United States Patent and Trademark Office

APPLICATION N	10.	FILING DATE	FIRST NAMED INVENTOR	ATTORNEY DOCKET NO.	CONFIRMATION NO.
10/659,384 09/11/2003		09/11/2003	Geum-Jong Bae	239/169 DIV	3795
27849	7590	09/27/2006		EXAMINER	
LEE & N		•	PHAM, HOAI V		
3141 FAI SUITE 50		PARK DRIVE	ART UNIT	PAPER NUMBER	
FALLS C	CHURC	H, VA 22042	2814		
				DATE MAILED: 09/27/2006

Application No.	Applicant(s)					
	10/659,384	BAE ET AL.					
Office Action Summary	Examiner	Art Unit					
	Hoai v. Pham	2814					
The MAILING DATE of this communication Period for Reply	appears on the cover sheet with the	correspondence address					
A SHORTENED STATUTORY PERIOD FOR RE THE MAILING DATE OF THIS COMMUNICATIO - Extensions of time may be available under the provisions of 37 CFF after SIX (6) MONTHS from the mailing date of this communication - If the period for reply specified above is less than thirty (30) days, a - If NO period for reply is specified above, the maximum statutory per - Failure to reply within the set or extended period for reply will, by str Any reply received by the Office later than three months after the mearned patent term adjustment. See 37 CFR 1.704(b).	N. R 1.136(a). In no event, h

FIG. 3e

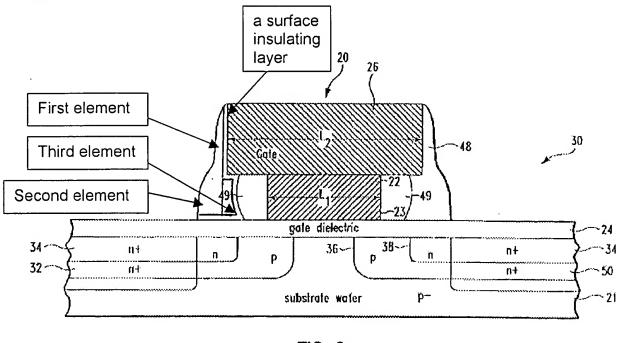
With respect to claims 20, Furukawa et al. discloses (fig. 3e, cols. 4-5) a semiconductor device comprising:

a T-shaped gate electrode (20) disposed on a semiconductor substrate (21), the T-shaped gate electrode (20) having a wide portion (26) and a narrow portion (22), the narrow portion disposed between the wide portion and the semiconductor substrate (21), so as to have an undercut region adjacent to the narrow portion;

an L-shaped lower spacer (48) covering a top surface of the semiconductor substrate at both sides of the T-shaped gate electrode (20) and covering sides of the wide portion of the T-shaped gate electrode (20), the L-shaped lower spacer (48) having a first element disposed substantially perpendicular to the semiconductor substrate (21), and having a second element disposed substantially parallel to the semiconductor substrate, the second element extending from the first element laterally away from the T-shaped gate electrode (20);

a low-concentration impurity region (34) formed in the semiconductor substrate at both sides of T-shaped gate electrode (20); and

a high-concentration impurity region (50) formed in the semiconductor substrate next to the L-shaped lower spacer (48).

With respect to claim 21, Furukawa et al. discloses that lower and upper conductive layer patterns (22 and 26) are sequentially stacked, wherein the upper conductive layer pattern (26) is wider than the lower conductive layer pattern (22) (see fig. 3e).

With respect to claim 22, Furukawa et al. discloses that the L-shaped lower spacer (48) further comprises a third element extending into the undercut region, the third element disposed substantially parallel to the semiconductor substrate and extending from the first element laterally towards the T-shaped gate electrode (fig. 3e).

With respect to claim 26, Furukawa et al. discloses that a surface insulating layer (48) intervened between the gate electrode (20) and the lower spacer (48) (see fig. 3e).

With respect to claim 27, Furukawa et al. discloses that the first element of the L-shaped lower spacer (48) completely covers sides of the wide portion (26) of the T-shaped gate electrode (20) (see fig. 3e).

With respect to claim 28, Furukawa et al. discloses that the second element of the L-shaped lower spacer (48) partially covers the narrow portion (22) of the T-shaped gate electrode (20) (see fig. 3e).

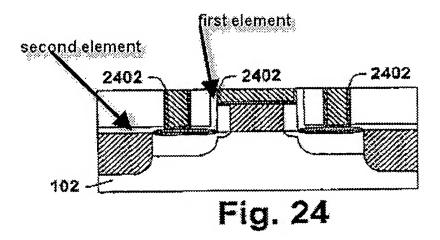
With respect to claims 20, Lopatin et al. discloses (fig. 24, cols. 2-9) a semiconductor device comprising:

a T-shaped gate electrode (104, 2402, 1604) disposed on a semiconductor substrate (102), the T-shaped gate electrode (104, 2402, 1604) having a wide portion (2402, 1604) and a narrow portion (104), the narrow portion disposed between the wide portion and the semiconductor substrate (102), so as to have an undercut region adjacent to the narrow portion;

an L-shaped lower spacer (2204) covering a top surface of the semiconductor substrate at both sides of the T-shaped gate electrode (104, 2402, 1604) and covering sides of the wide portion of the T-shaped gate electrode (2402, 1604), the L-shaped lower spacer (2204) having a first element disposed substantially perpendicular to the semiconductor substrate (102), and having a second element disposed substantially parallel to the semiconductor substrate, the second element extending from the first

element laterally away from the T-shaped gate electrode (104, 2402, 1604), wherein the first element and the second element intersect to define a substantially 90 degree angle in an outer surface of the L-shaped lower spacer (2204);

With respect to claim 22, Lopatin et al. discloses that the L-shaped lower spacer (2204) further comprises a third element (124, 126) extending into the undercut region, the third element disposed substantially parallel to the semiconductor substrate and extending from the first element laterally towards the T-shaped gate electrode (see fig. 24).

With respect to claim 27, Lopatin et al. discloses that the first element of the L-shaped lower spacer (2204) completely covers sides of the wide portion (2402, 1604) of the T-shaped gate electrode (104, 2402, 1604) (see fig. 24).

With respect to claim 28, Lopatin et al. discloses that the second element of the L-shaped lower spacer (2204) partially covers the narrow portion (104) of the T-shaped gate electrode (104, 2402, 1604) (see fig. 24).

With respect to claim 29, Lopatin et al. discloses that thicknesses of the first and second elements are approximately the same (see fig. 24).

With respect to claim 30, as best understood, Lopatin et al. discloses that the surface insulating layer (124, 126) completely fills the undercut region (see fig. 24).

With respect to claim 31, Lopatin et al. discloses that wherein the surface insulating layer (124, 126) completely fills the undercut region and a third element of the L-shaped lower spacer (2204) completely covers the undercut region (see fig. 24).

Applicant's arguments are not persuasive because Lopatin et al. clearly discloses an L-shaped lower spacer (2204) having a first element and a second element that intersect to define a substantially 90 degree angle in an outer surface (see fig. 24).
